DESIGN ADVISORY BOARD Tuesday November 10, 2020 3:00 PM REMOTE MEETING

MEMORANDUM

To: Design Advisory Board
From: Scott Gustin
Re: 160 Bank Street
Date: November 10, 2020

Request: Construct gallery seating area with canopy on south side – seeking alternative compliance as to gallery dimensions

SITE PLAN - PROPOSED
1/16" = 1'-0"

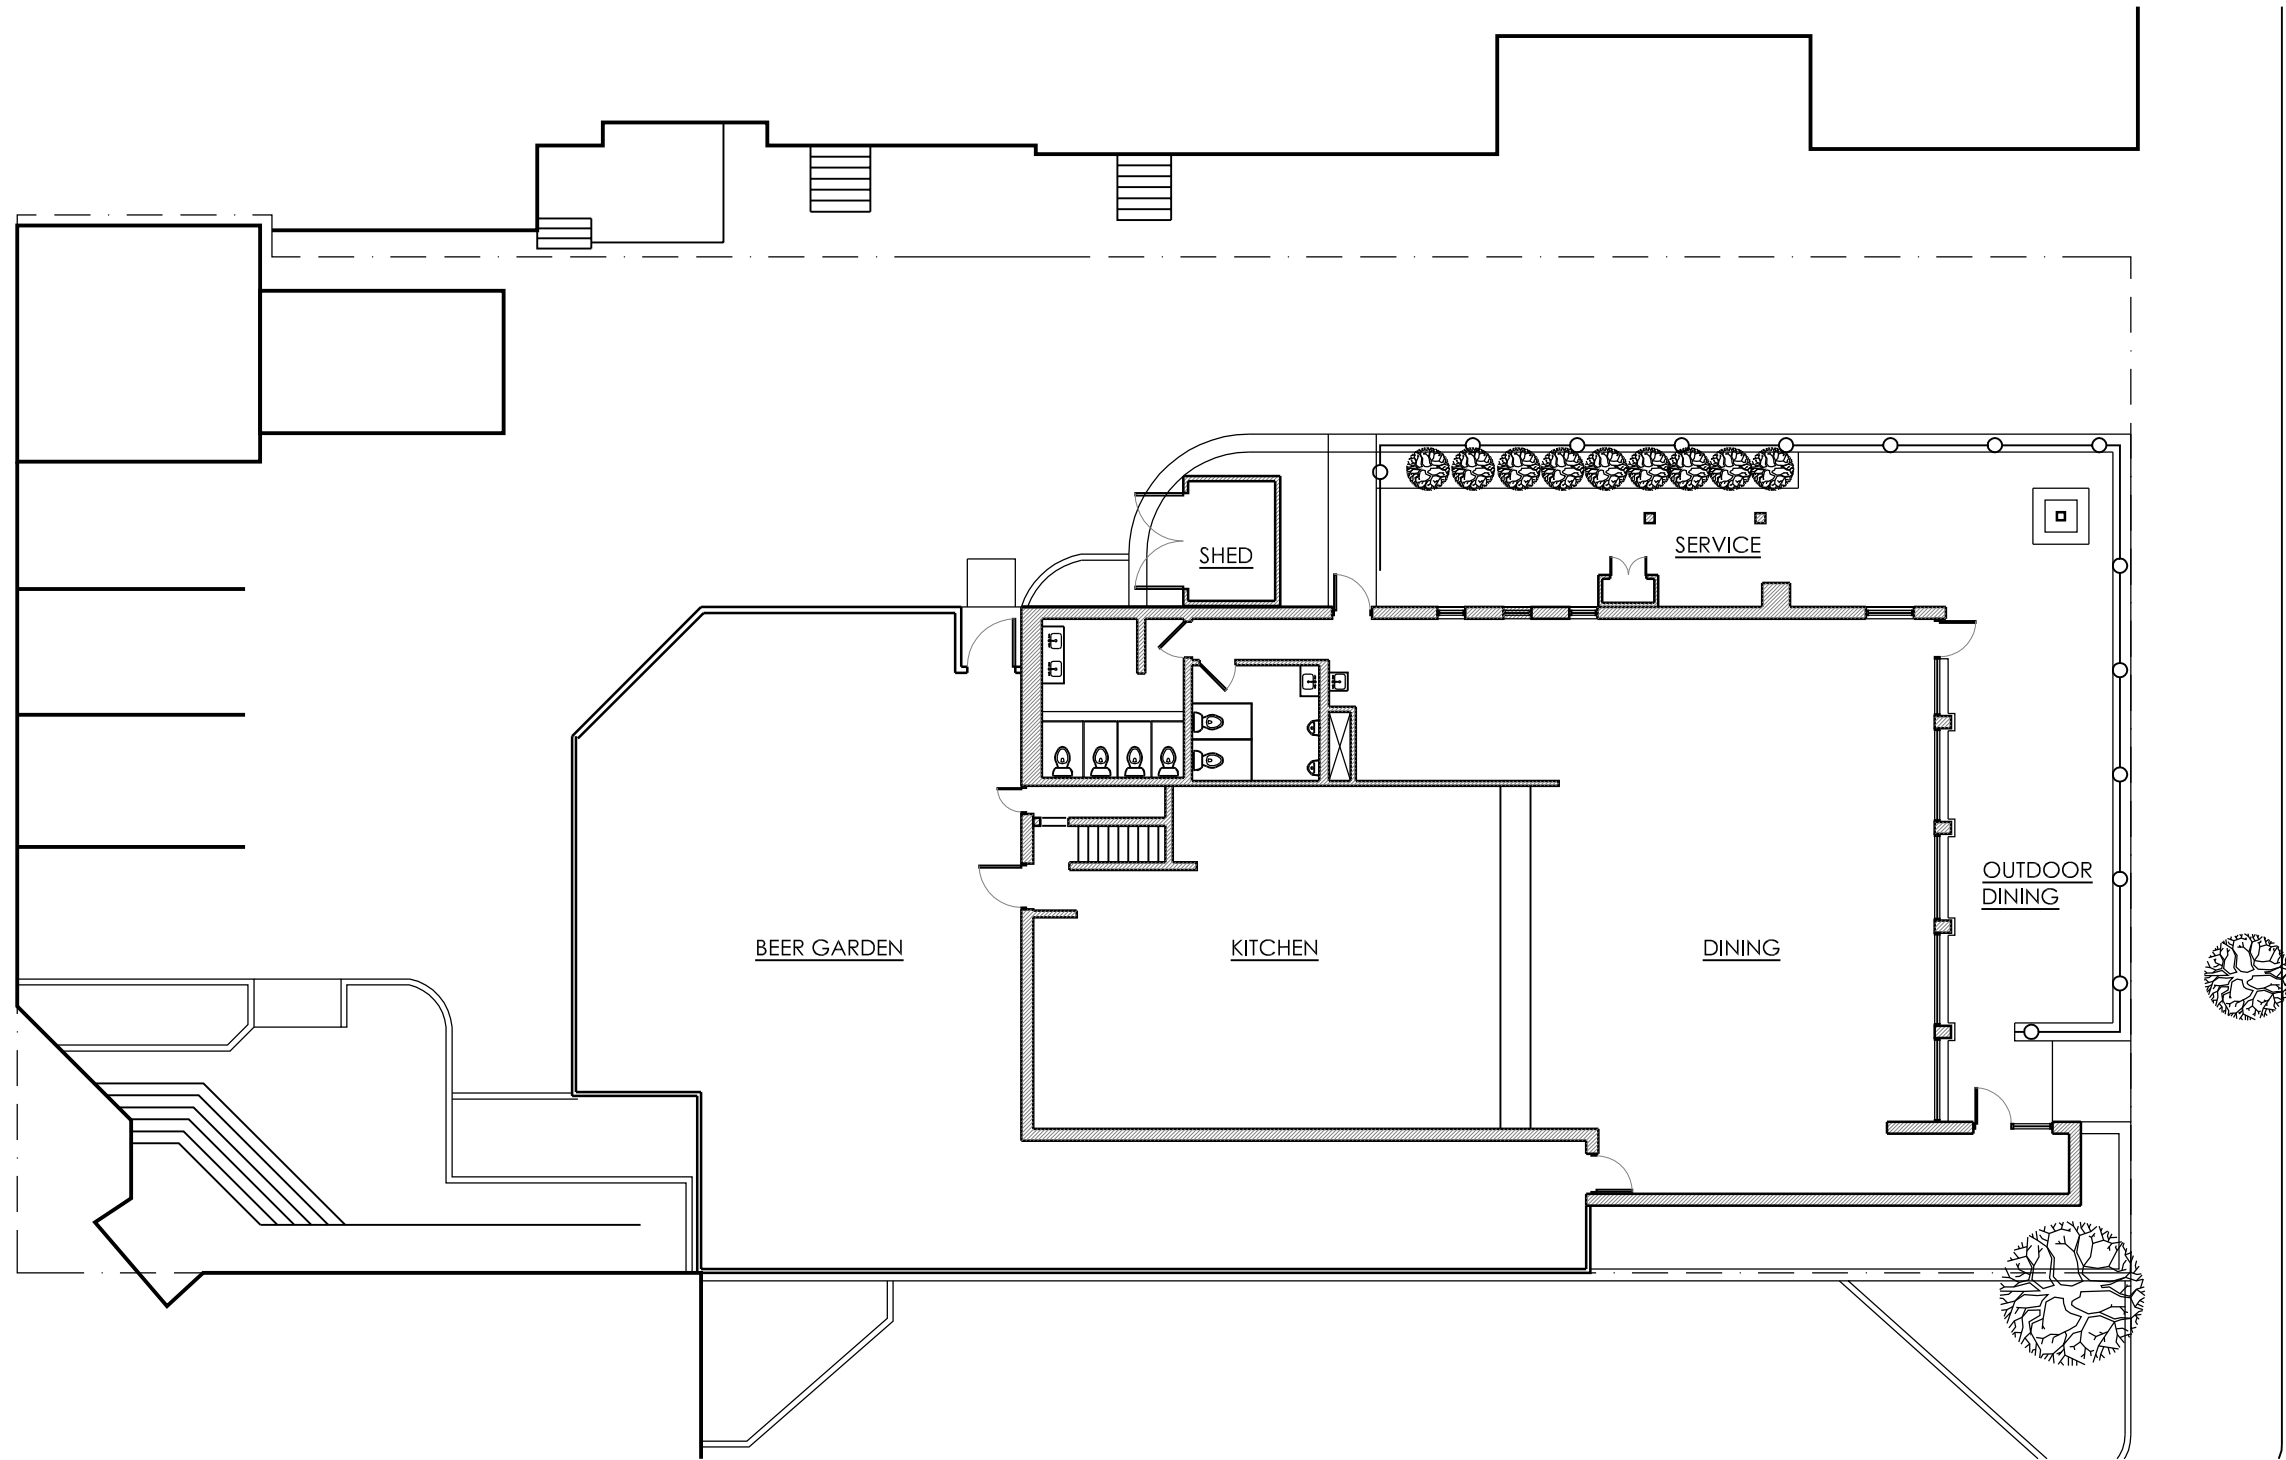
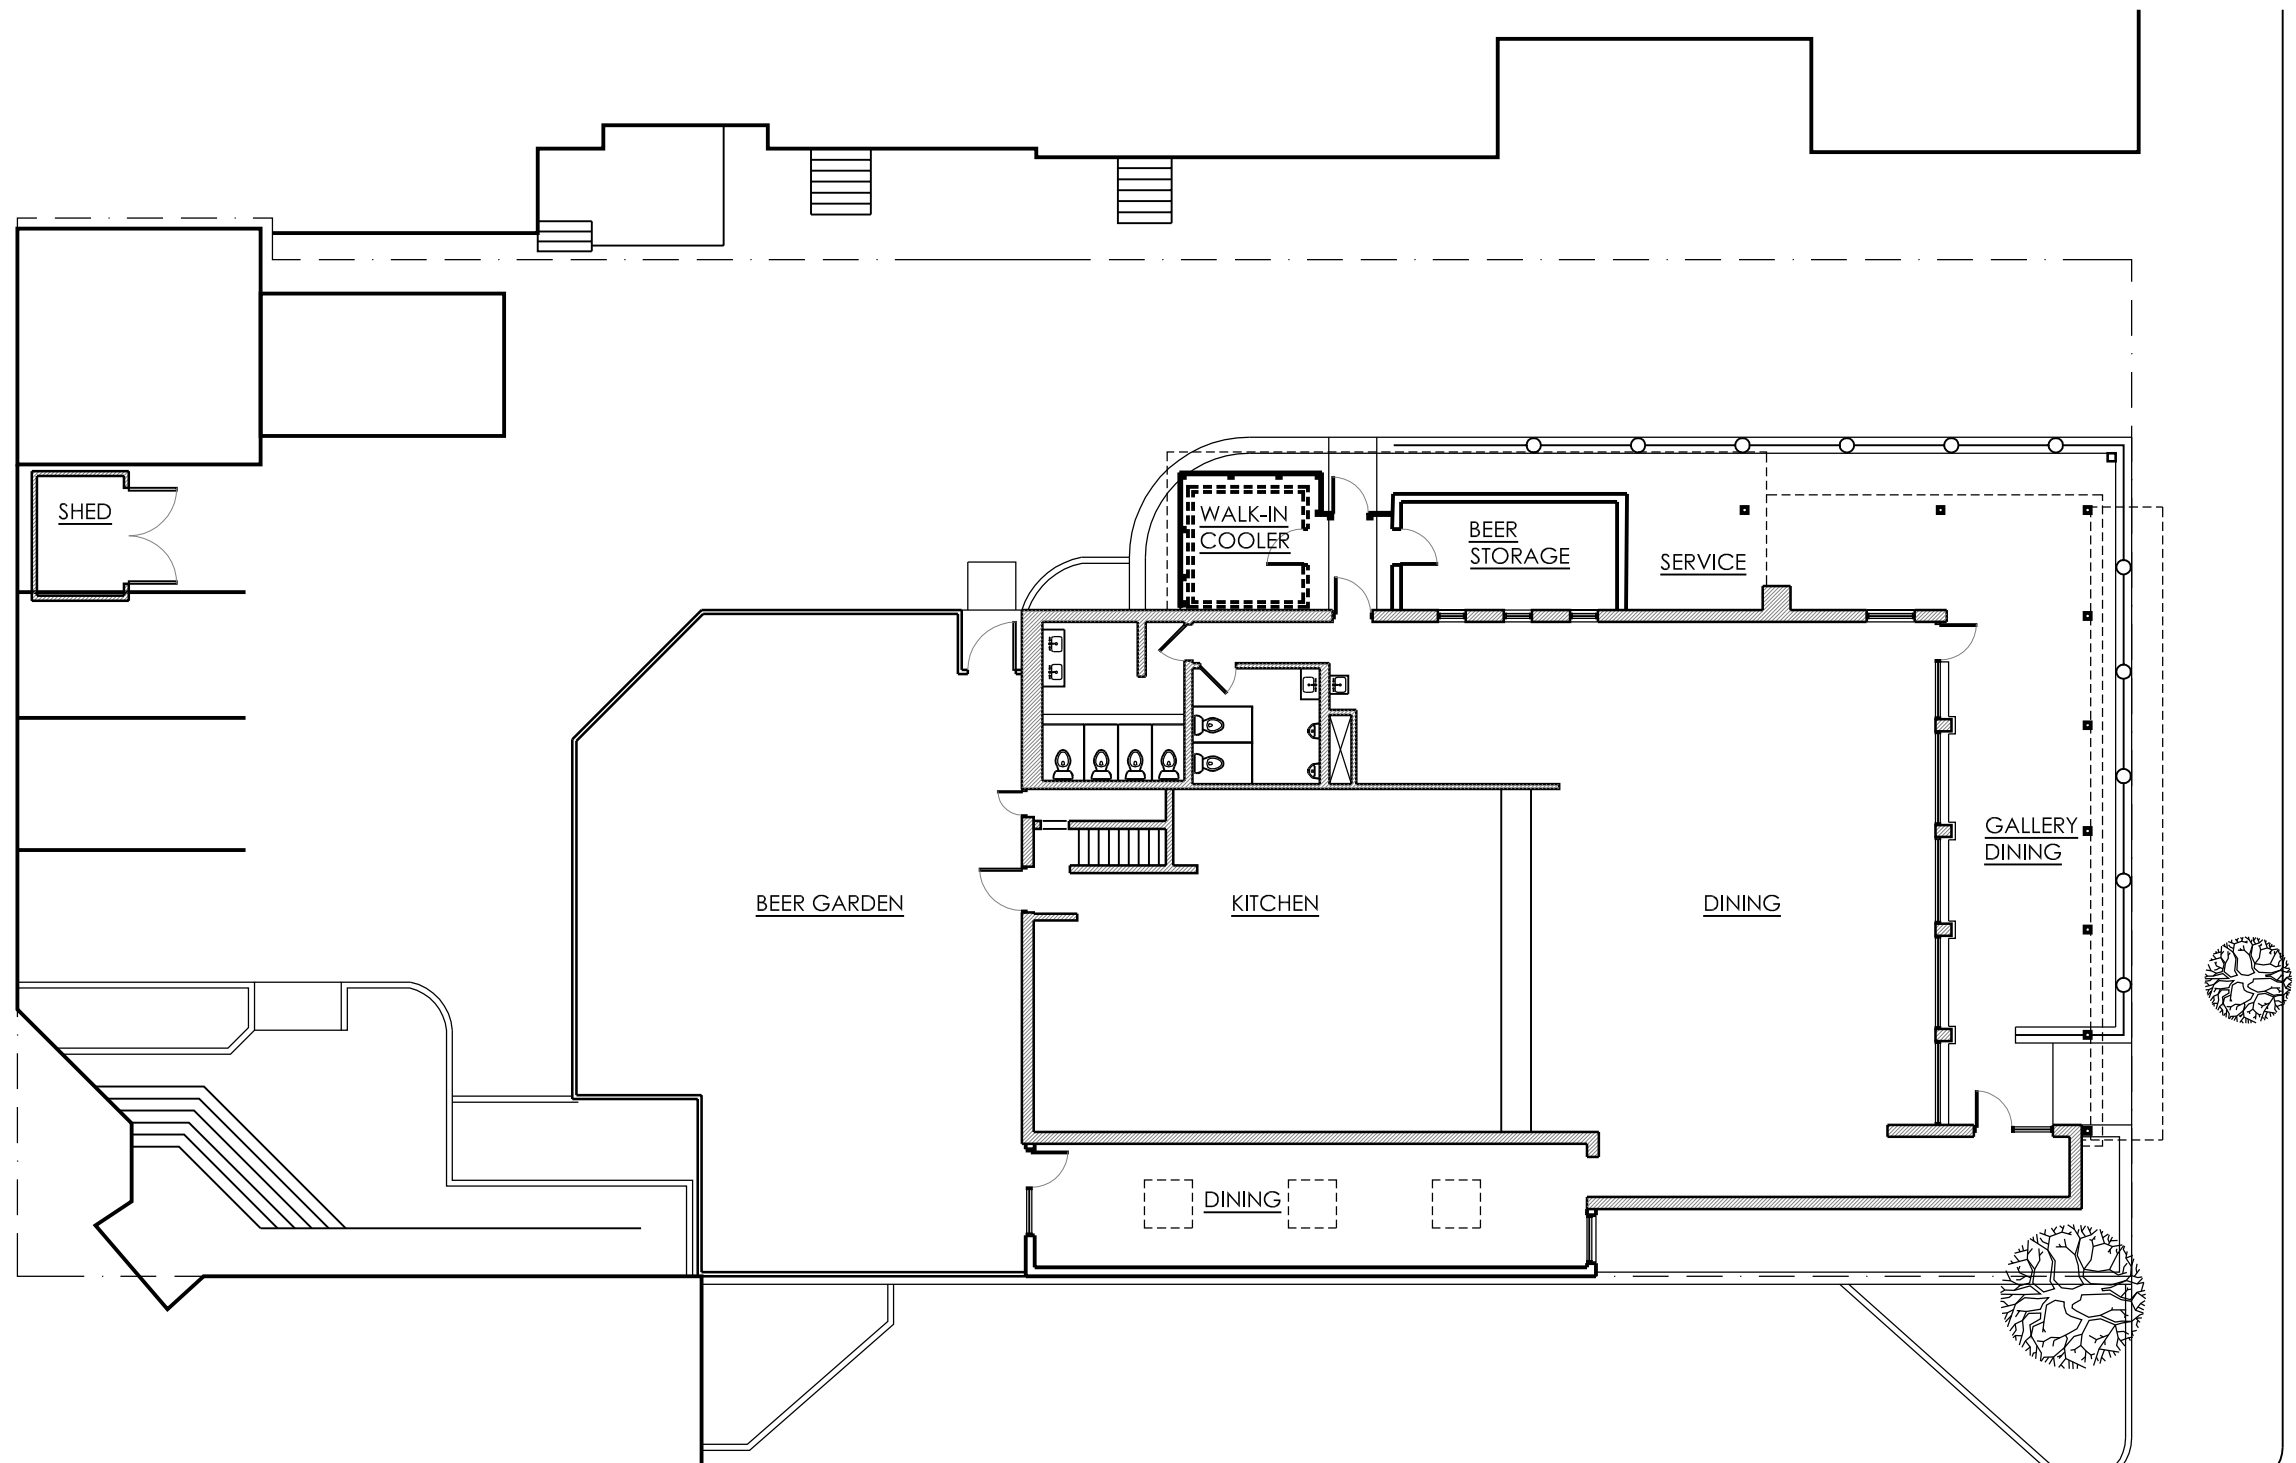
Up to 20% relief from numerical standards may be granted by the Development Review Board following recommendation by the Design Advisory Board. In this case, the 12' gallery depth proposed represents the maximum 20% relief possible from the 10' maximum gallery depth standard.

The proposed gallery, along with the canopy, will cover essentially the entire outdoor dining area in front of the building. Narrower dimension may fall short of providing full cover.

Limiting the gallery to 10' depth would fall short of the intended purpose of sufficiently sheltering the outdoor seating area in front of the building. The 2' wider dimension will achieve the desired end goal with little perceptible difference as viewed from the street. The gallery as proposed clearly reads as intended for this frontage type. It is simply 2' wider than would otherwise be allowed.

Recommend approval and forward to the Development Review Board as submitted.

SITE PLAN

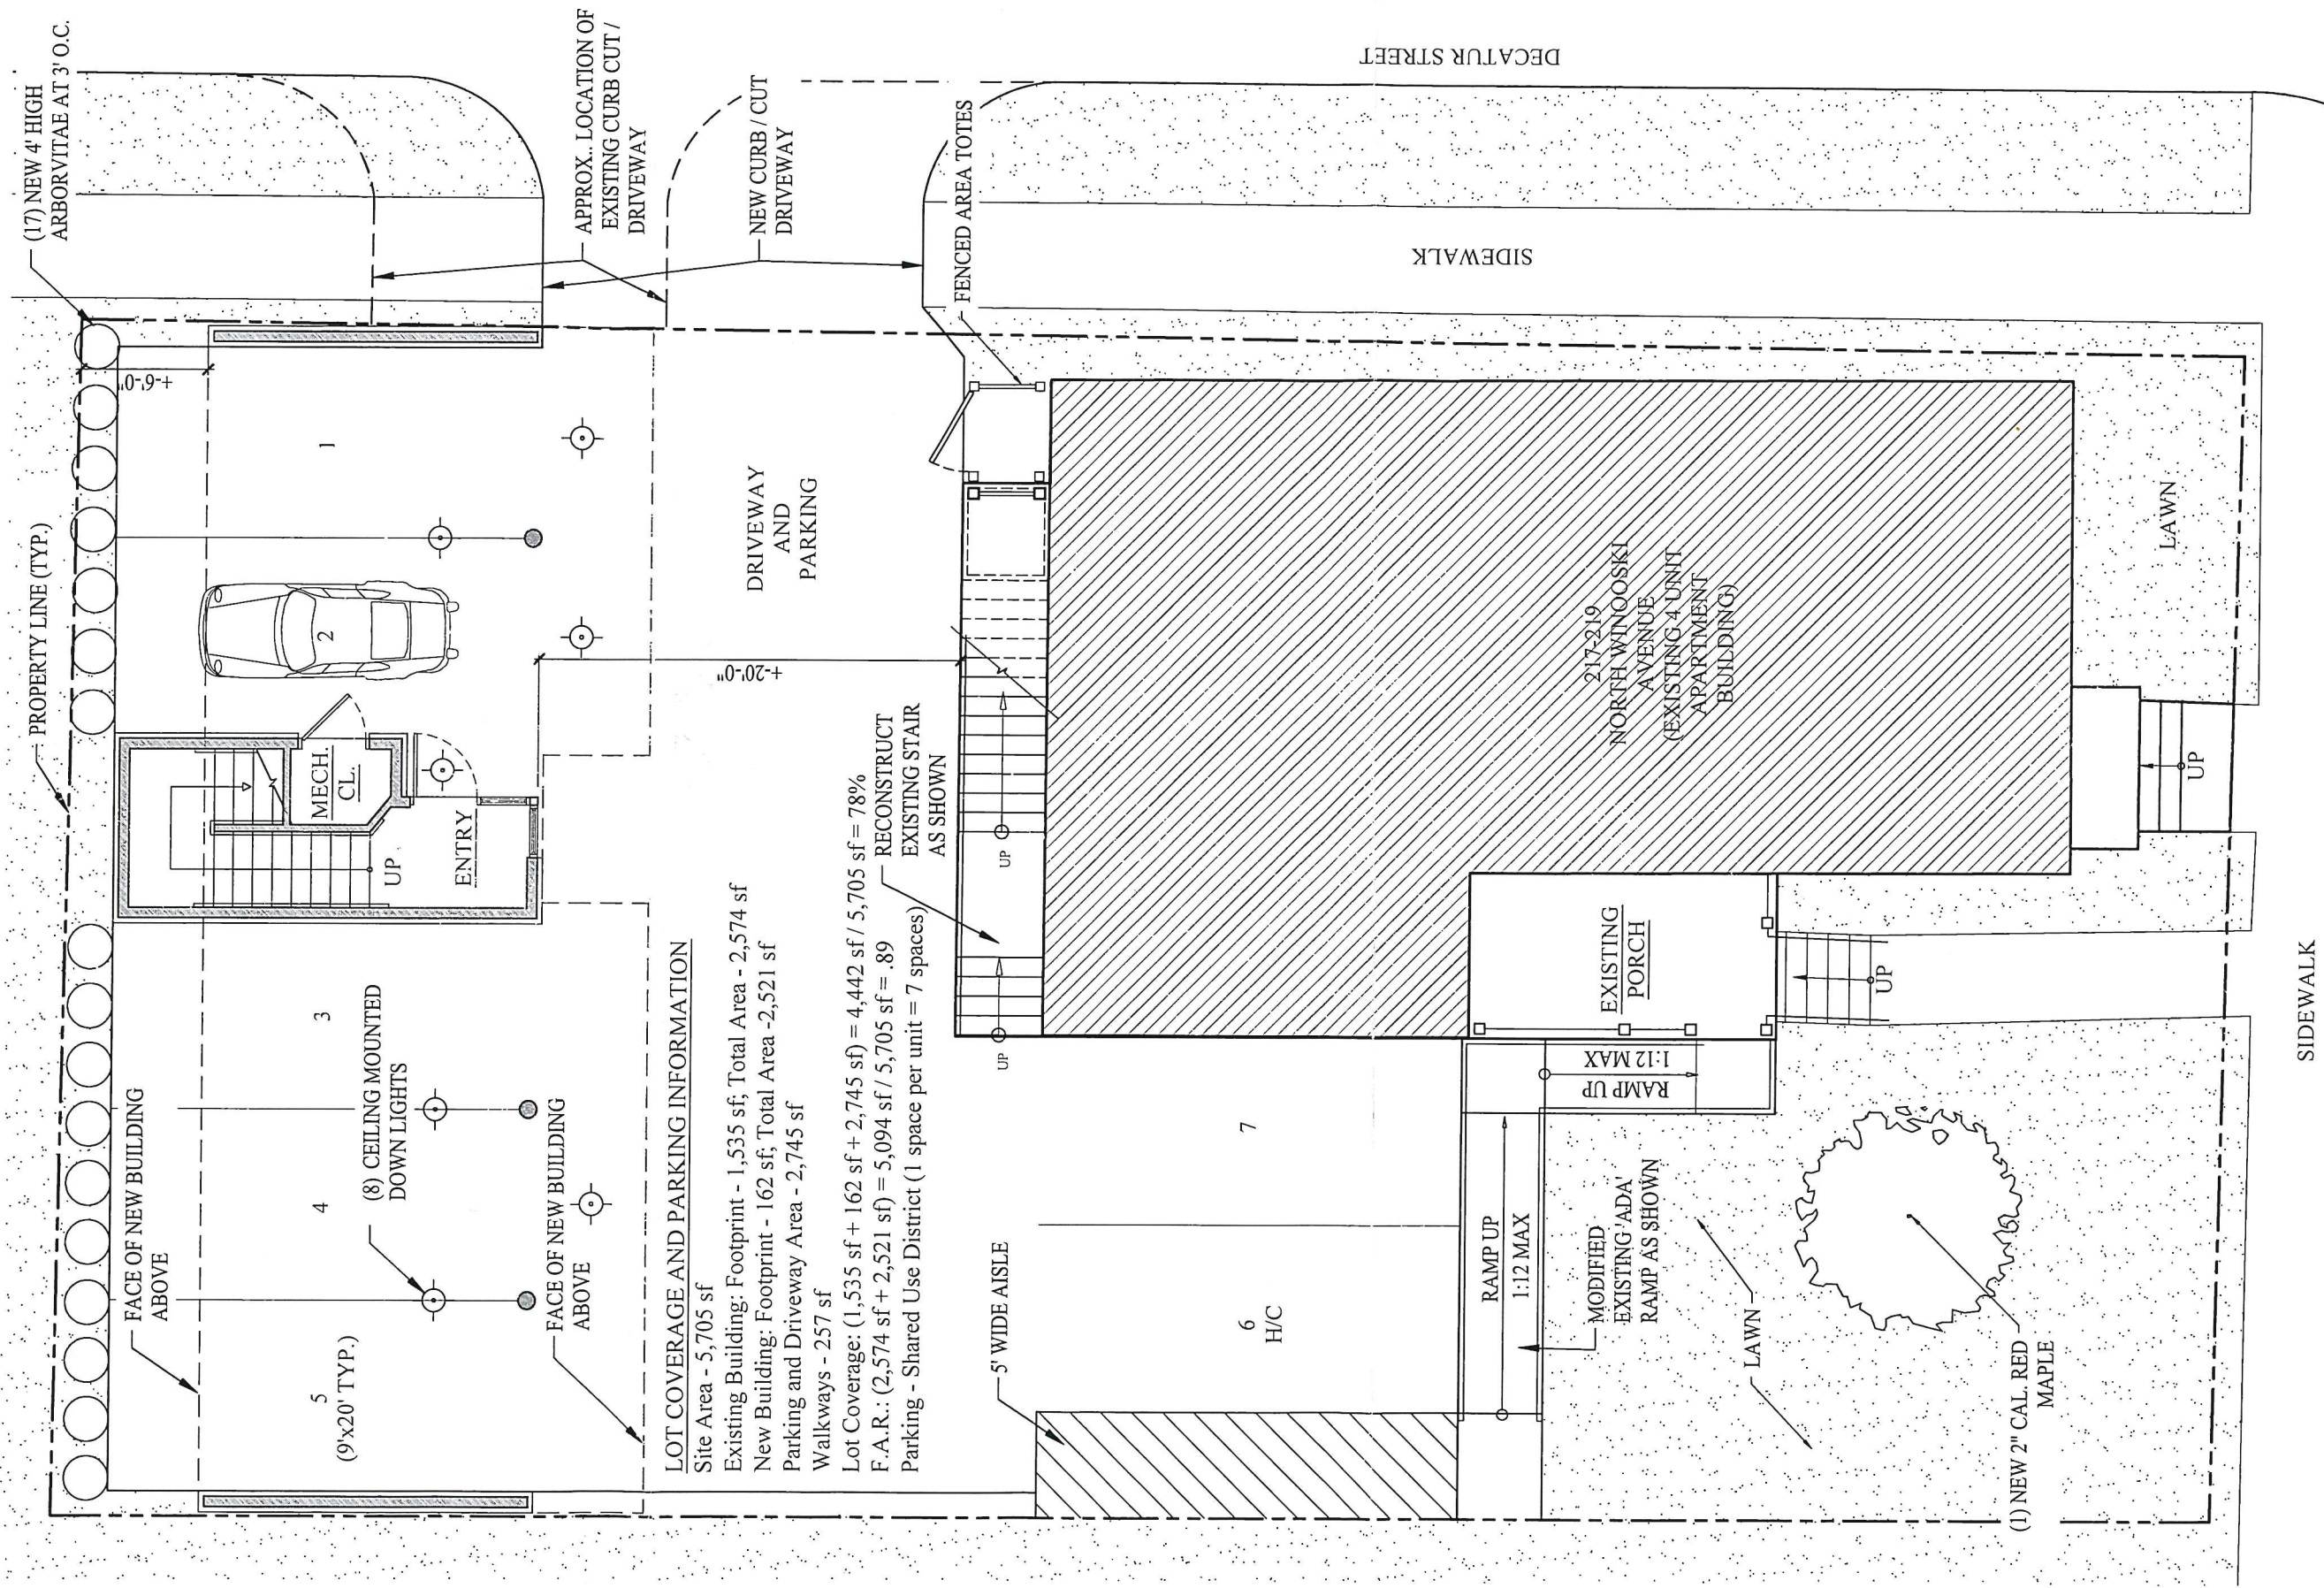
The proposal includes shifting the curb cut off Decatur Street 8 ft to accommodate the footprint of the new building. This access is the only vehicular access to the property and will serve both buildings. The plans indicate 5 parking spaces at the ground level of the new structure and 2 spaces to the side of the existing four-plex. Internally, there will be approx. 20 ft of driveway width to maneuver vehicles.

The proposal does not include a direct and unobstructed pedestrian path between the primary building entrance and the public sidewalk. In order to access the building, pedestrians will have to utilize the driveway and walk behind two parking spaces to access the new building. This does not conform with the requirement to provide a physical separation between pedestrians and vehicles.

Seven on site parking spaces are illustrated on the site plan, with an internal driveway width of approx. 20 ft. As part of the Multi-modal multi-use parking district, there are no longer any minimum parking requirements, however the proposal includes on-site parking.

Three rooftop condenser units are proposed. A small garbage/recycling enclosure is shown on the site plan along the back side of the existing structure. Due to the small size and the potential 7 residential units, it is suspected that additional garbage/recycling facilities will be needed. Other mechanical units and utility meters are not included in the plans and need to be if they are to be placed outside or on the exterior of the new structure.

1. Provide a direct and unobstructed pedestrian path between the primary building entrance and the public sidewalk.
2. Pull the NE façade back from the street to align with the adjacent buildings and/or develop the façade to have more visual interest, such as by treating the ground floor differently, change the plane of the NE elevation, or variation in materials.
3. Shield, delete or relocate the ceiling mounted downlights to prevent glare from the sidewalk.
4. Show mail box locations
5. Clarify roof access and parapet design.
6. Provide information on adjacent building heights, such as with elevations, renderings, or photos.
